Product Change Notice

Issue Date: 01-April-2021

Introduction of new dice sources

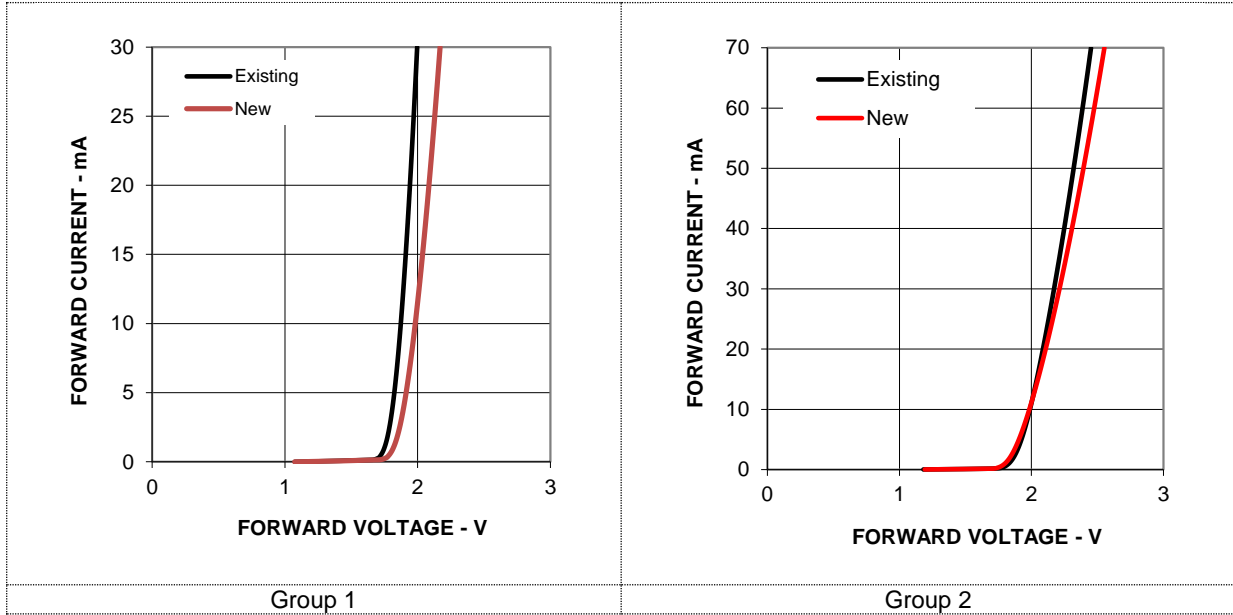
Discontinue of current dice supply

There will be no change on fit, form, quality and reliability of final product. Vf characteristic is slightly difference as illustrated below:
